MEMO

To:	Lee's Summit Water Utilities Department Attn: Mr. Jeff Thorn 1200 SE Hamblen Road Lee's Summit, MO 64081
From:	Kevin Waldron, PE
RE:	Water Tower Re-Coating Phase 2 – Woods Chapel and Scherer Lee's Summit, Missouri - 2022 Additional and Revised Recommendations
Date:	December 20, 2022
Project #:	C17-0717

This memo provides Olsson's findings, analysis, recommendations and cost implications for Woods Chapel interior and Scherer Tower exterior re-coatings.

PHOTO #3

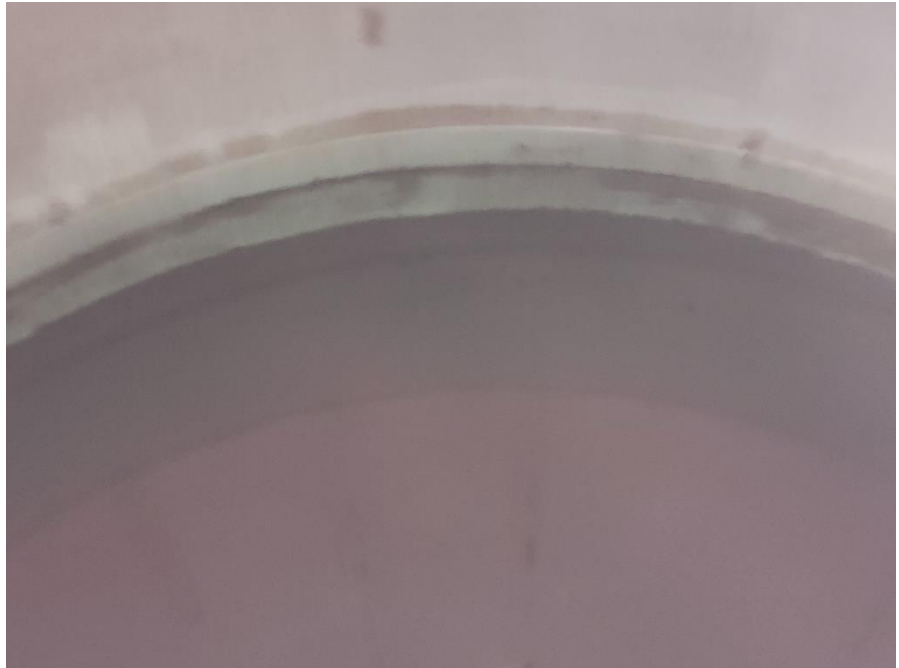
Area of bottom where belly meets the shell.

PHOTO #4

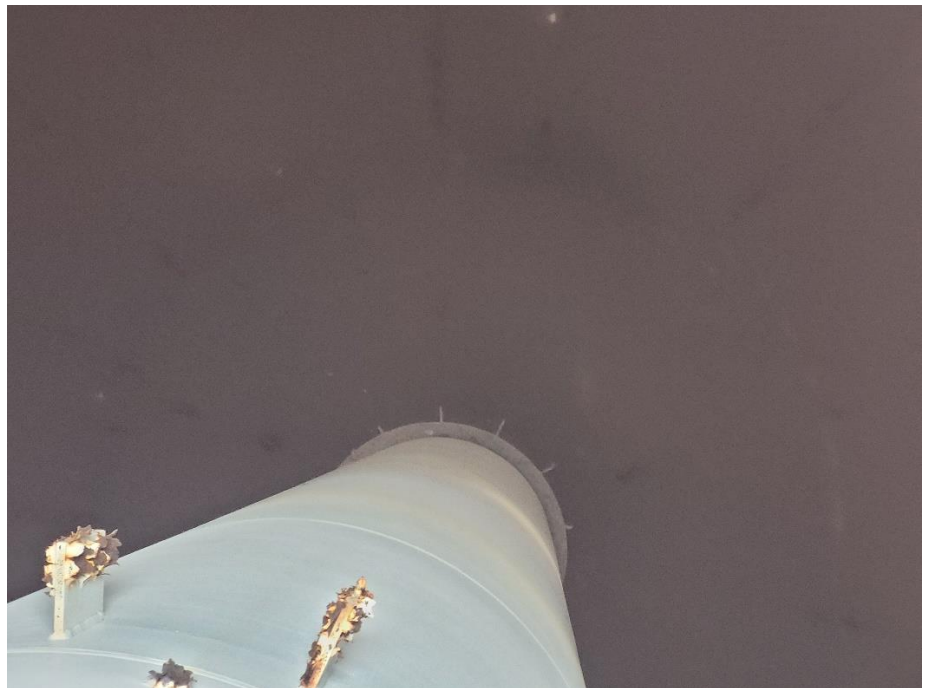
Looking down riser, water on bottom of tank.

PHOTO #7

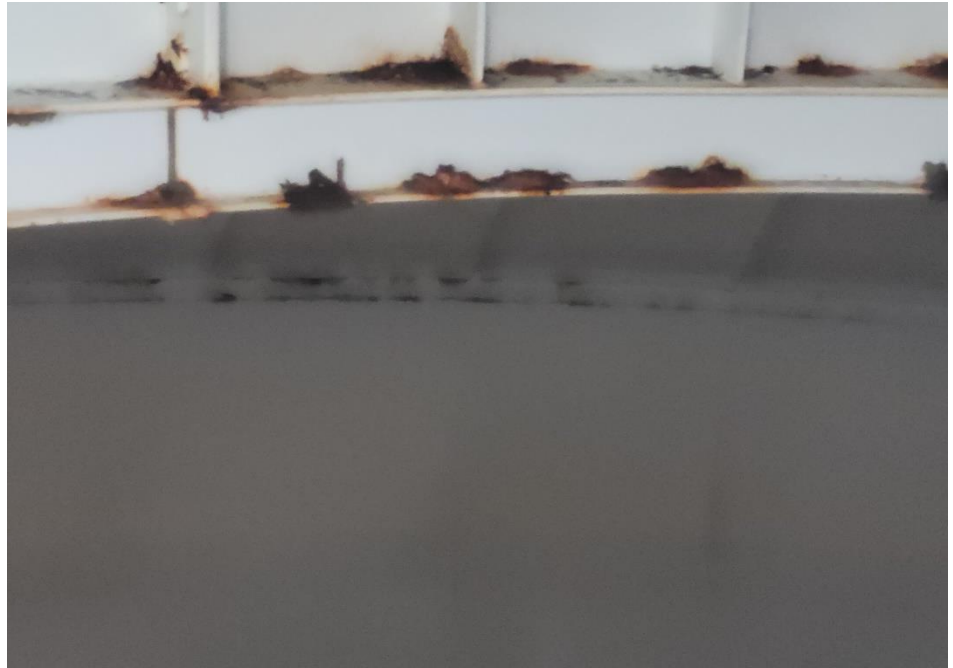
Painters rail with corrosion.
